PROPOSED IMPROVEMENT BRIDGE PROJECT TOWN OF MORRISTOWN COUNTY OF LAMOILLE CADYS FALLS ROAD (T.R. 2) MAJOR COLLECTOR BRIDGE NO. 8

MORRISTOWN
BF 0239 (3)

PROJECT DESCRIPTION: INCLUDES CLEANING AND PAINTING THE EXISTING STRUCTURAL STEEL SUPERSTRUCTURE, MINOR REPAIRS AND ASSOCIATED WORK.

Record Plans
Contractor: MODERN PROTECTIVE COATINGS, INC.
Resident Engineer: SCOTT WHEATLEY
Construction Began: JUNE 20, 2016
Construction Complete: NOVEMBER 17, 2016
Record Plans By: SCOTT WHEATLEY & JESSE IVES

(1) - 1R1 RAIL LAYOUT

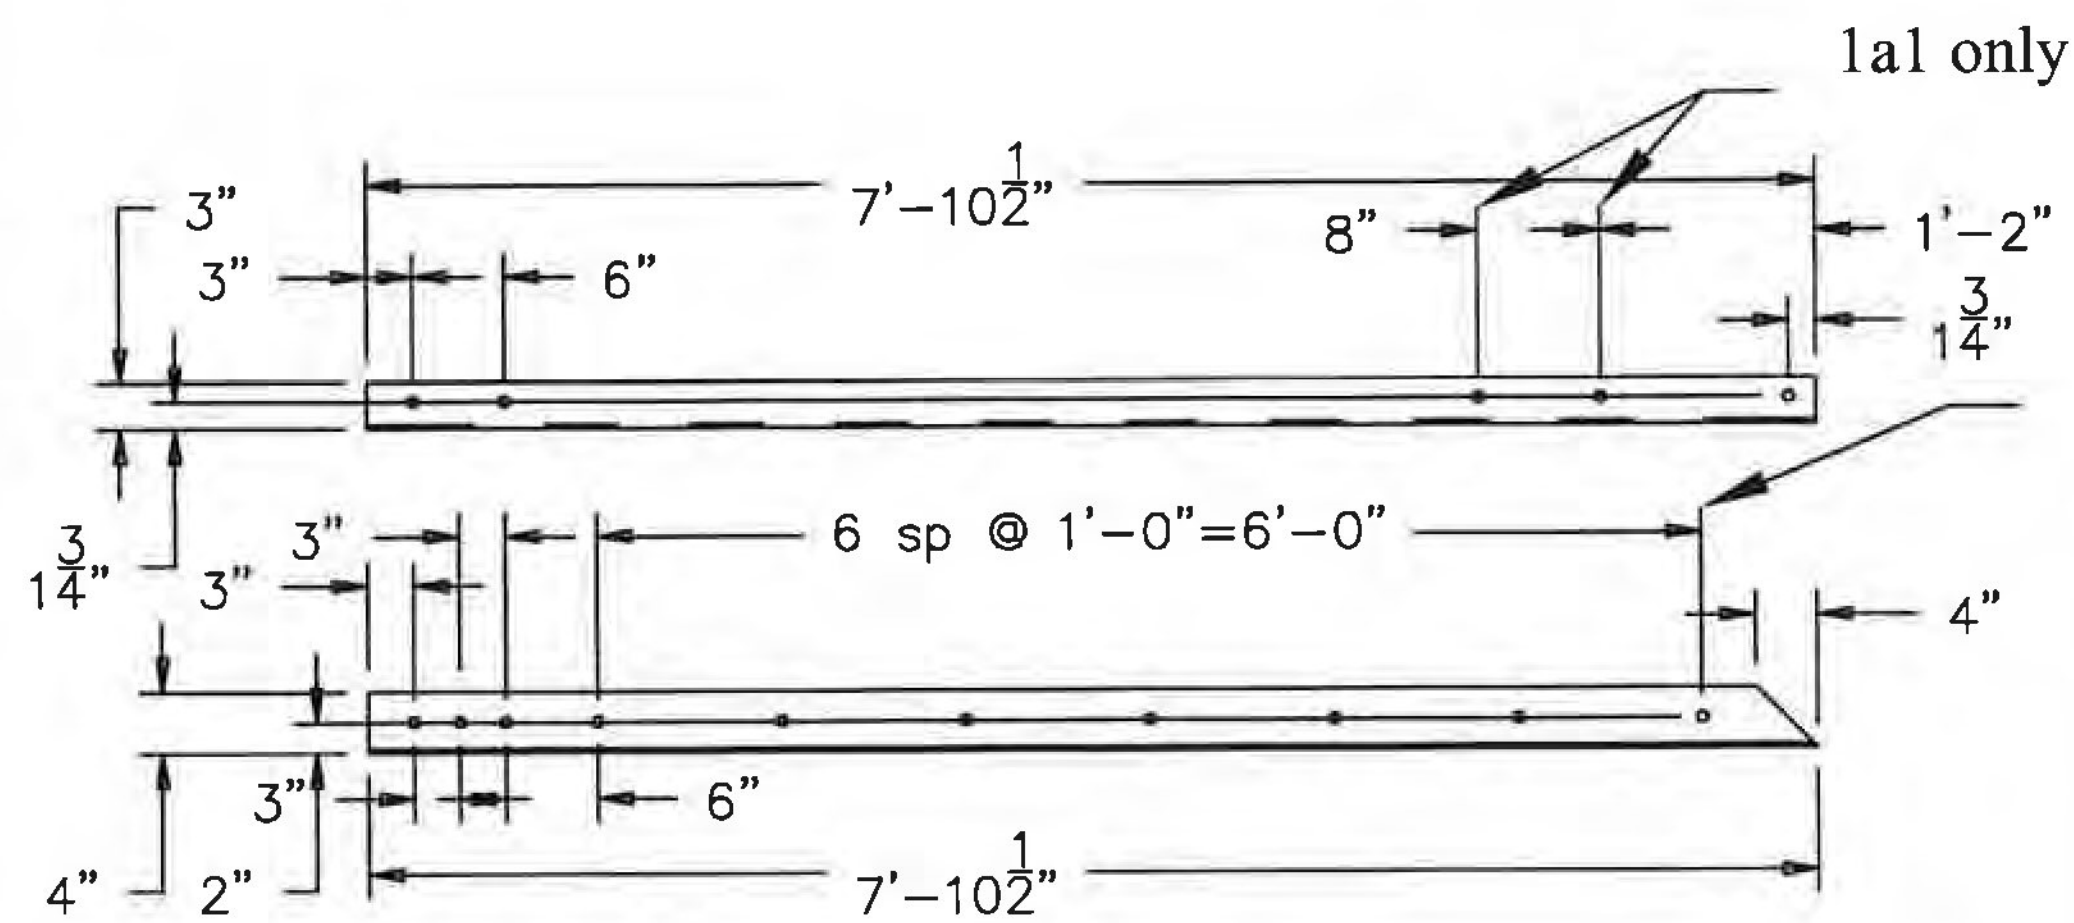
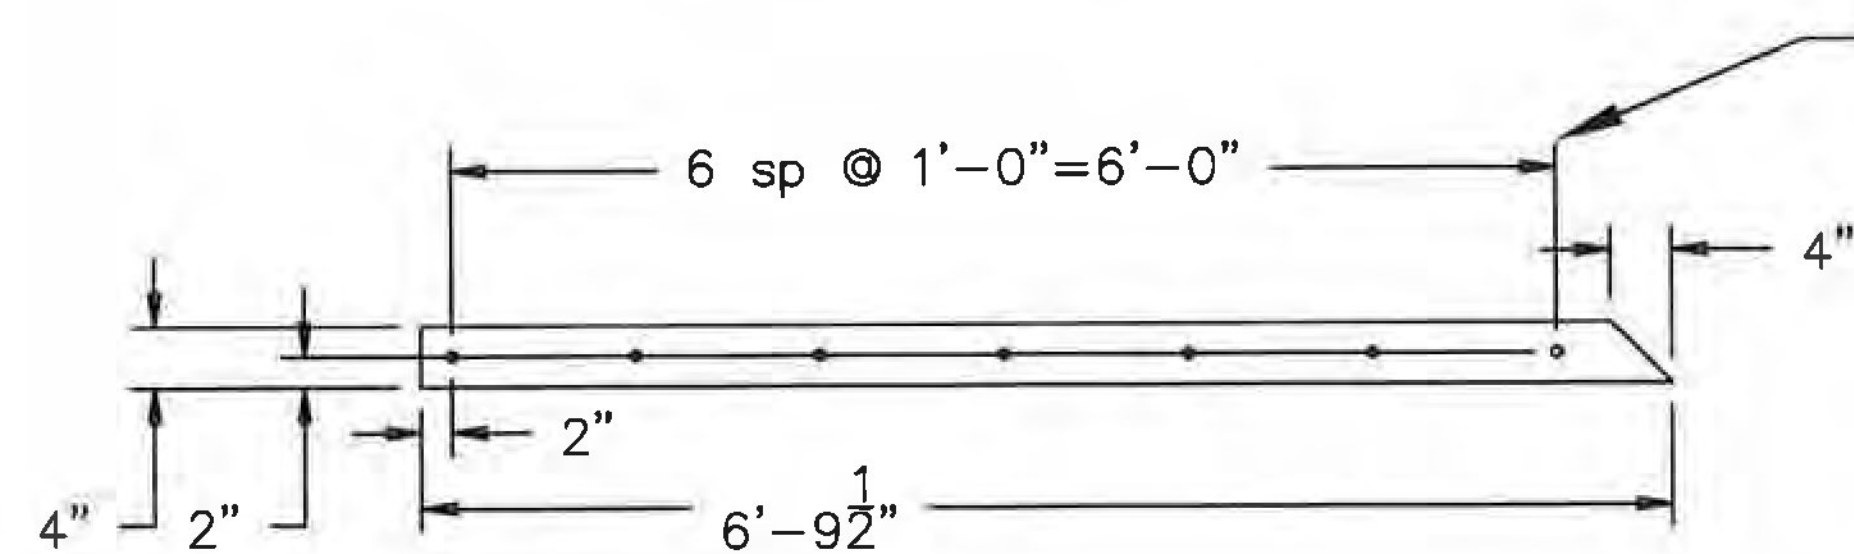
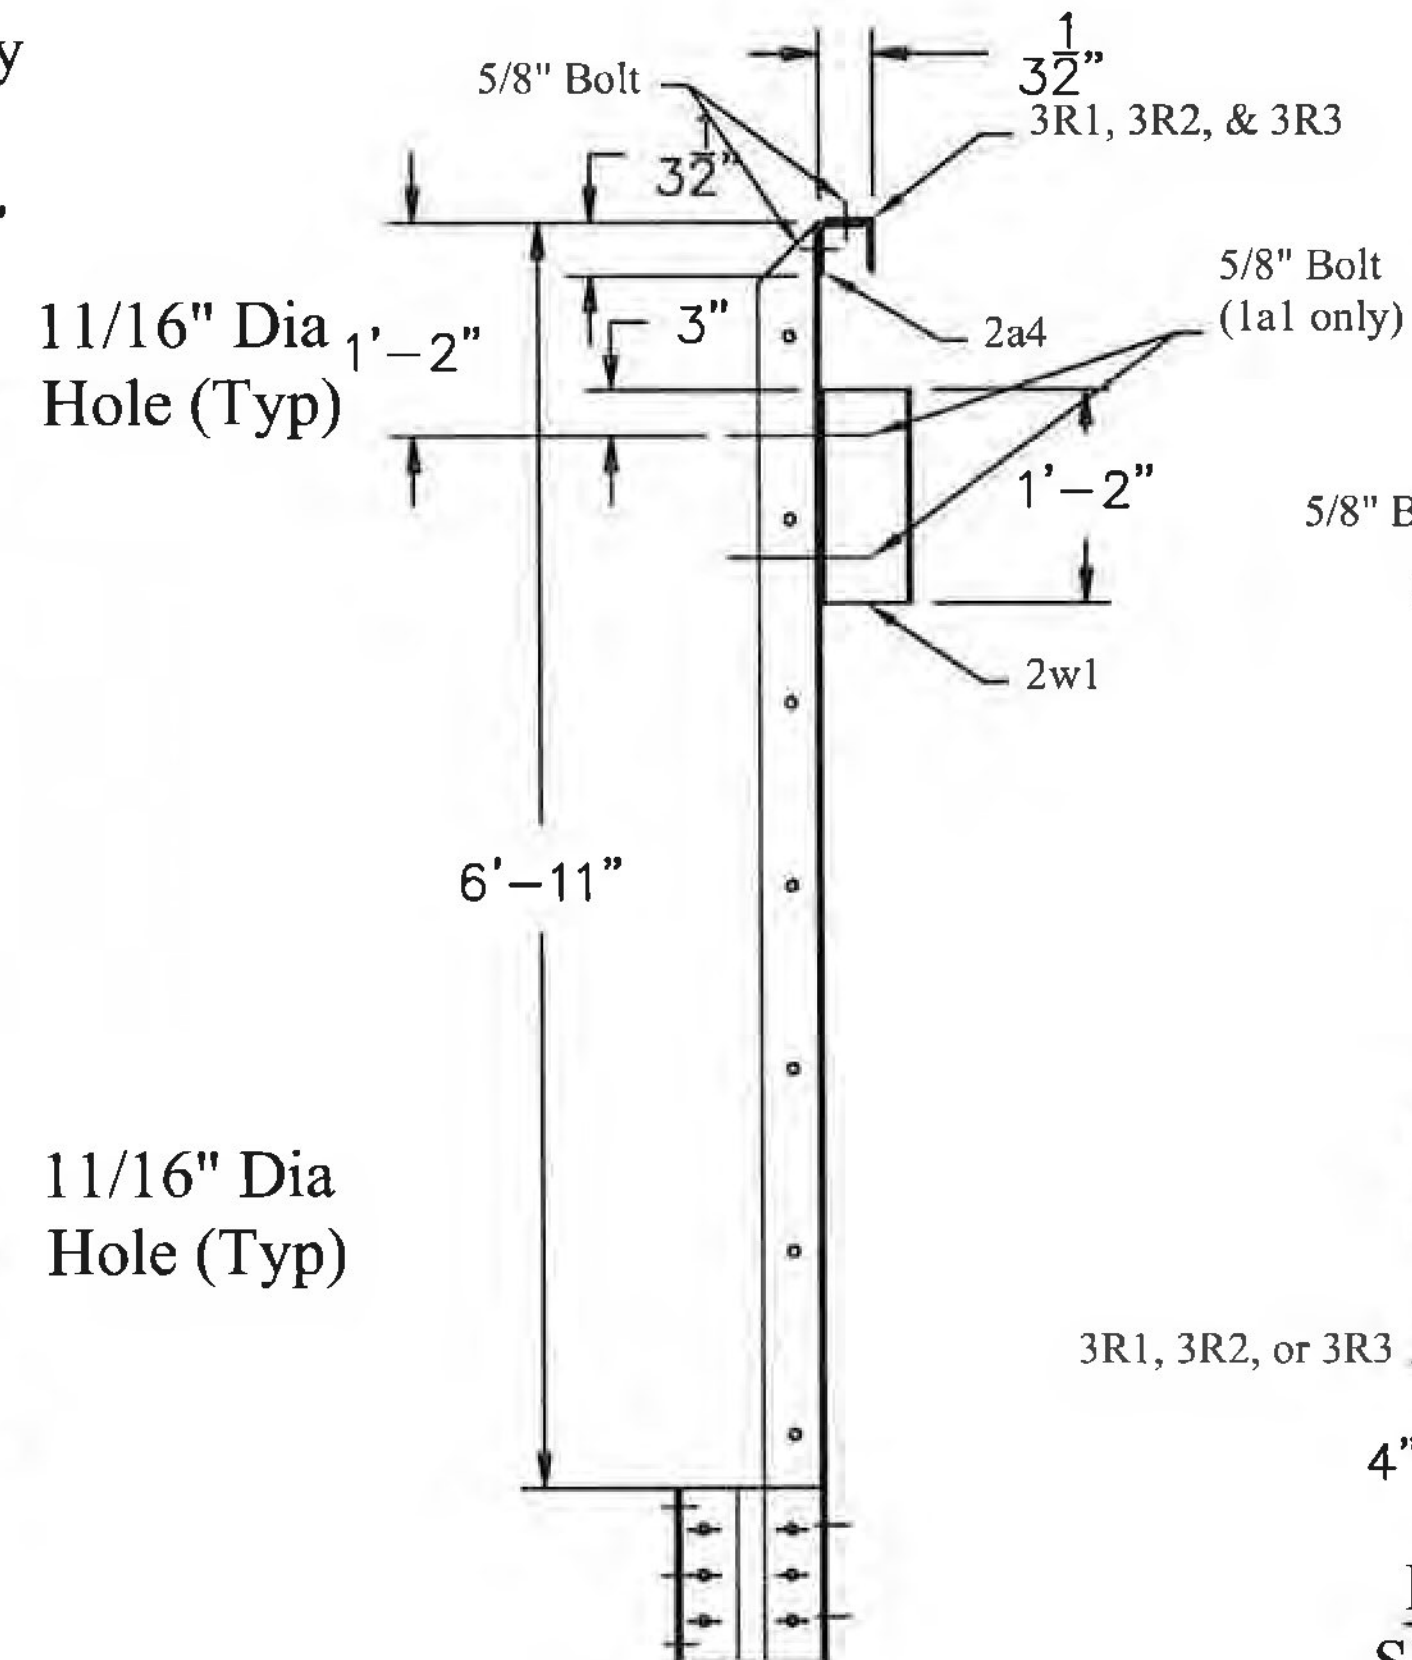
REVISE AND RESUBMIT

This review by Stantec Consulting Services Inc. is for the sole purpose of ascertaining conformance with the general design concept. This review shall not mean that Stantec Consulting Services Inc. approves the detail design inherent in the shop drawings, responsibility for which shall remain with the Contractor. Submitting same, and such review shall not relieve the Contractor of his responsibility for errors or omissions in the shop drawing or of his responsibility for meeting all requirements of the Contract Documents. The contractor is responsible for dimensions to be confirmed and correlated at the job site, for information that pertains solely to the fabrication processes or to techniques of construction and installation and for coordination of the work of all subtrades.

# BILL OF MATERIALS

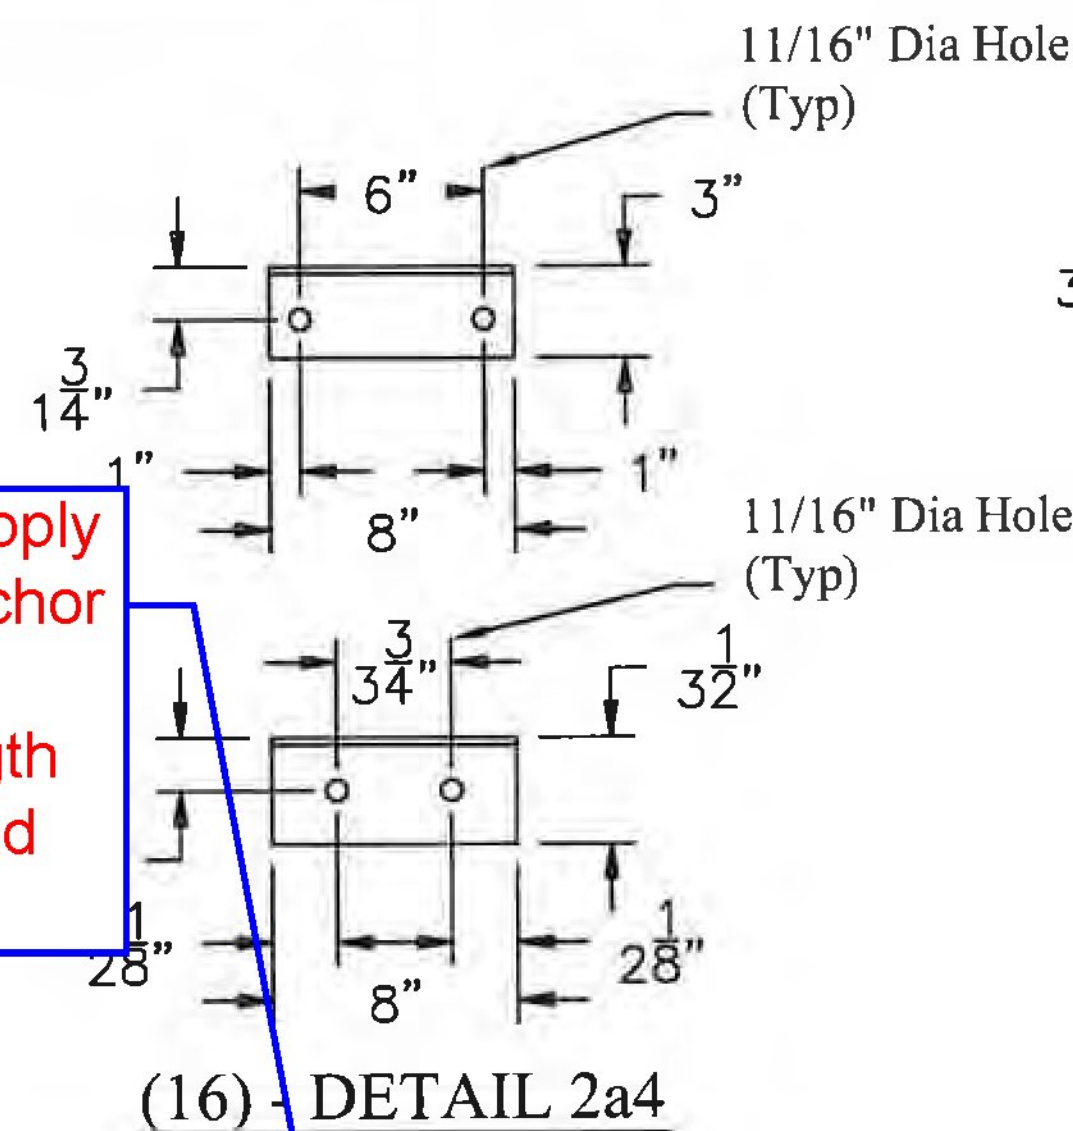
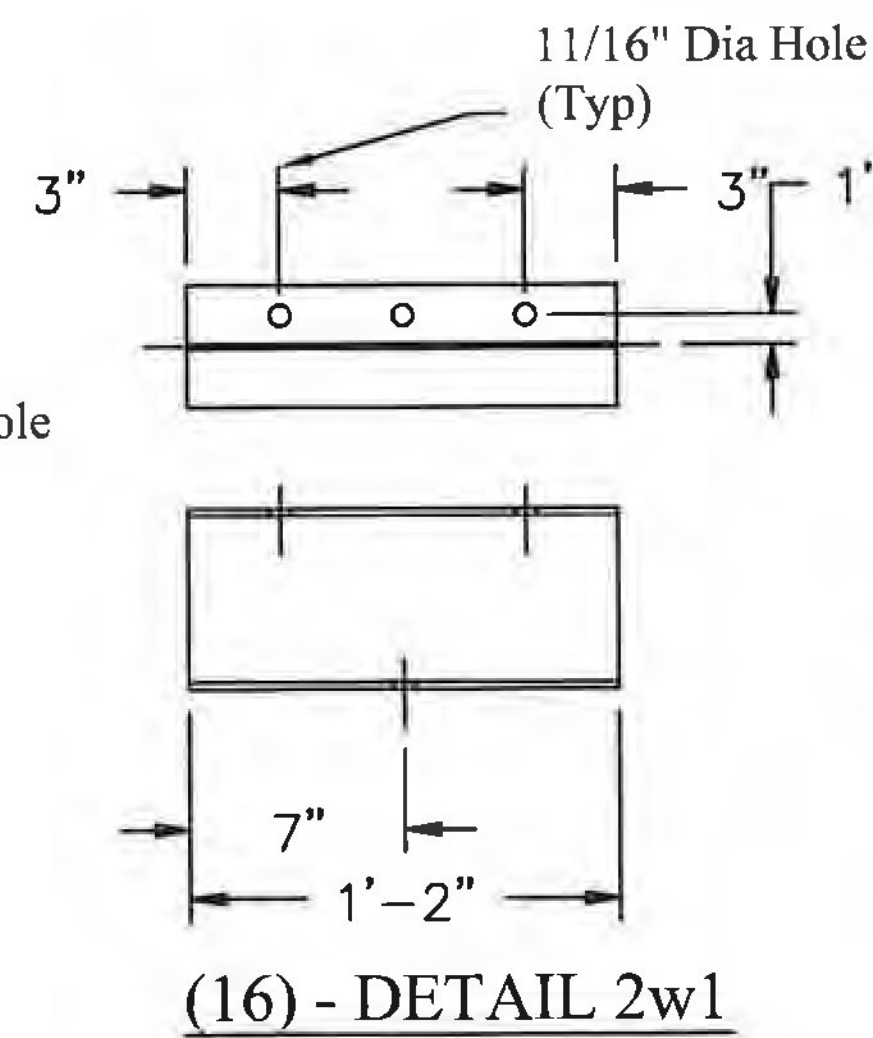
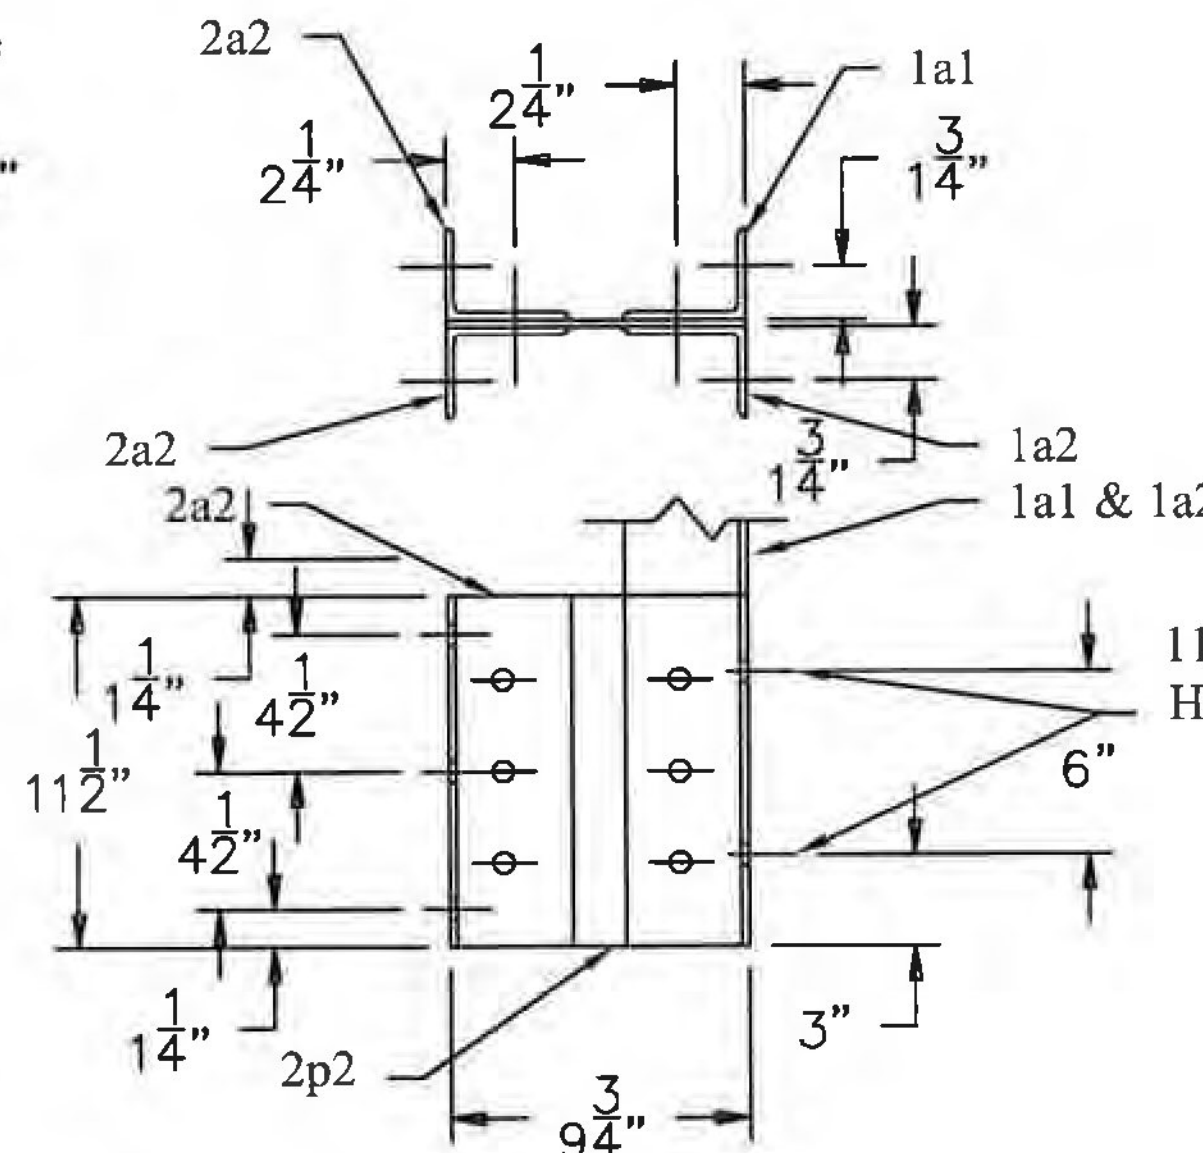
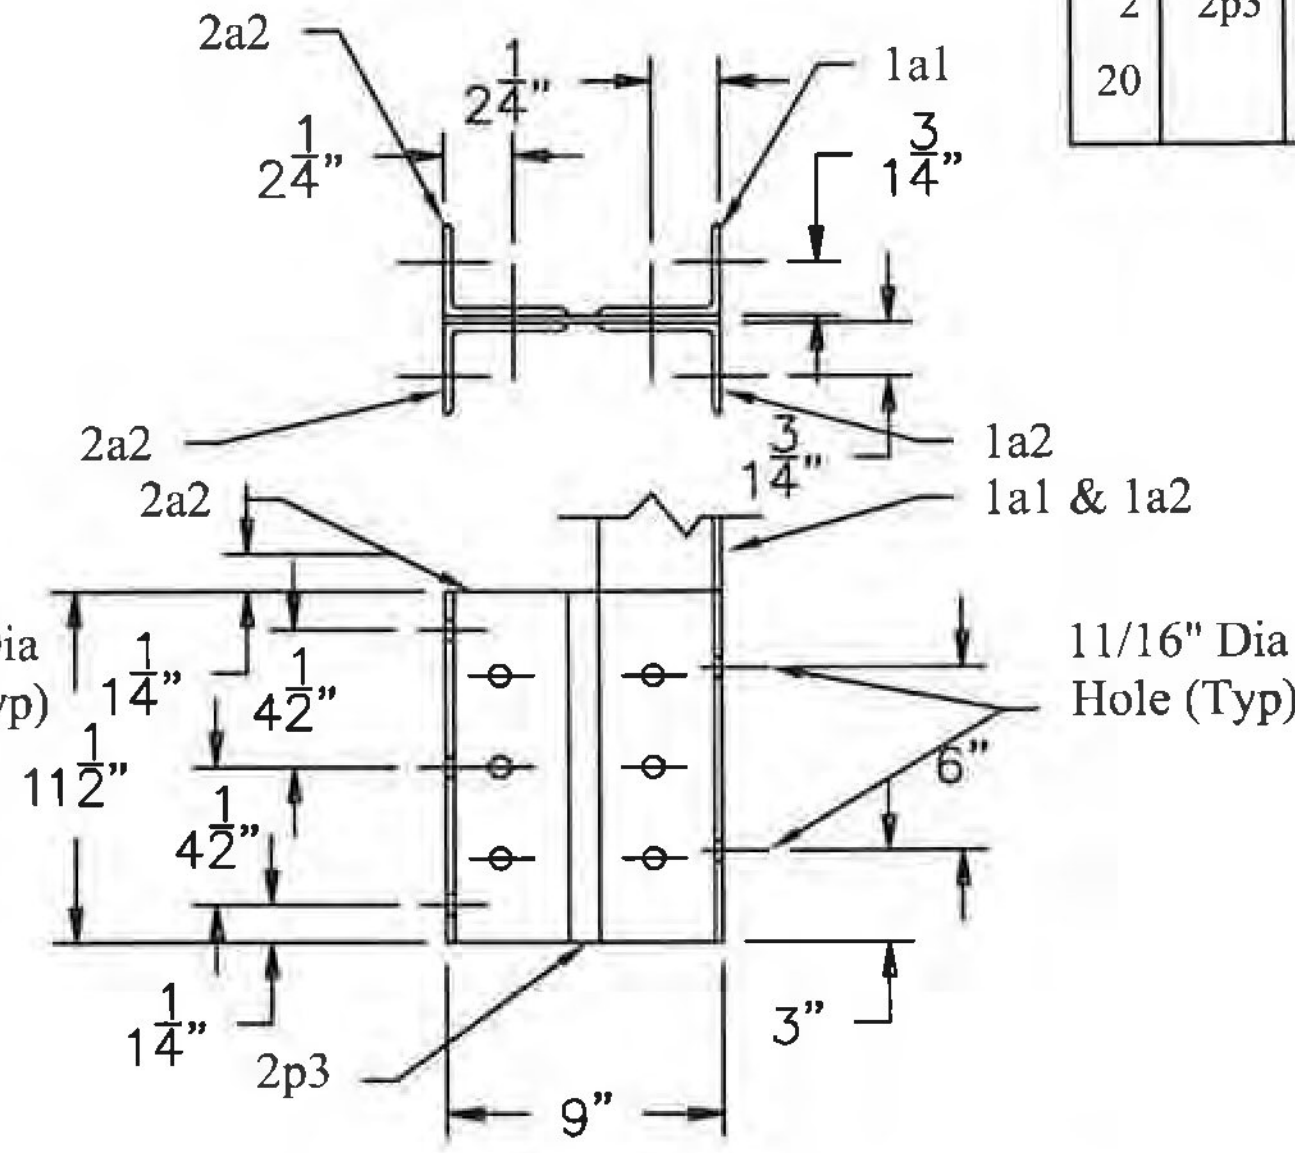
Contractor to supply threaded rod anchor details with embedment length and ultimate bond strength
